Solicitation No. 26-ENV-0010

Amendment No. 1

QUESTIONS AND ANSWERS

Underground storage tank removal.
Solicitation 26-ENV-0010 / 3450036558

Site Map

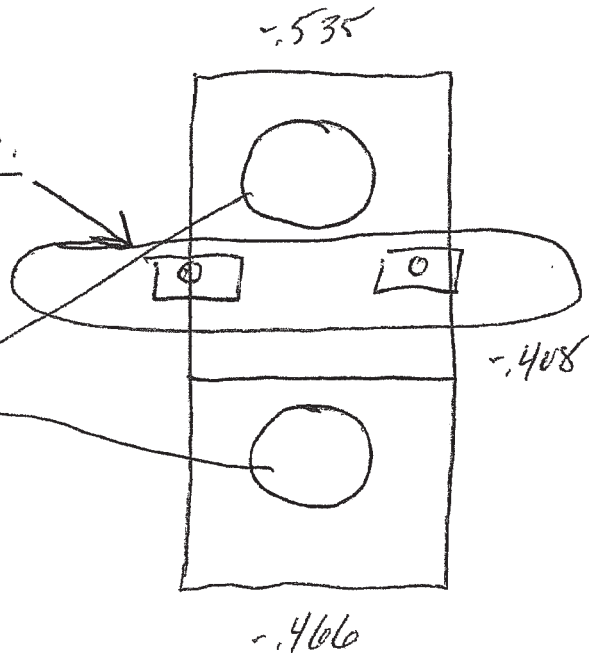
Q 5: Are historical UST installation drawings, piping diagrams, or site utility maps available for the three facilities?

A 5: See attached.
